D212-664-101

Item Name: Crosstube Fwd High

DART AEROSPACE LTD		Work Order:	94409
Description: Crosstube High Fwd (205/212/412)		Part Number:	D212-664-101
Inspection Dwg: D212-664-141 Rev: D		Page 1 of 1

DRAWING NO. D212-664-141	TITLE XTUBE ASSY (205/212/412 HI FWD)	REV. D	DART AEROSPACE LTD ENGINEERING ORDER		D.E.O. NO. D212-664-141-D-1	SHEET NO. SHEET 1 OF 2	SCALE NTS
DRAWN	CHECKED	OP	MFG. APPR.	APPROVED	DE APPR.		
DATE 11.04.07	DATE 11.07.11		DATE 11.04.12	DATE 11/04/12	DATE 11.04.12

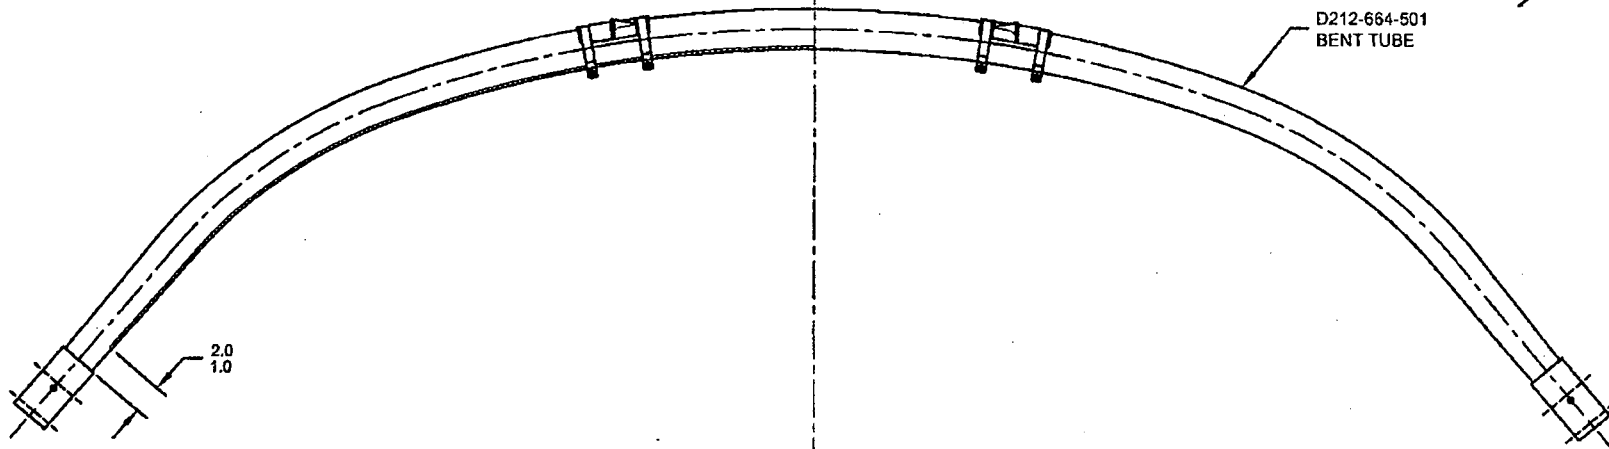
ADD AN INSPECTION WINDOW TO UNDERSIDE OF CROSSTUBE.

MASK AREA PRIOR TO PAINTING.
REMOVE MASKING AFTER PAINT
AND APPLY CLEAR COAT

- 2) FINISH: CHEMICAL CONVERSION COAT PER DART QSI 005 4.1
PRIME INSIDE AND OUTSIDE PER DART QSI 005 4.2
MASK UNDERSIDE OF CROSSTUBE AS SHOWN (HATCHED AREA) AND
PAINT OUTSIDE PER DART QSI 005 4.2
REMOVE MASKING AND APPLY CLEAR COAT
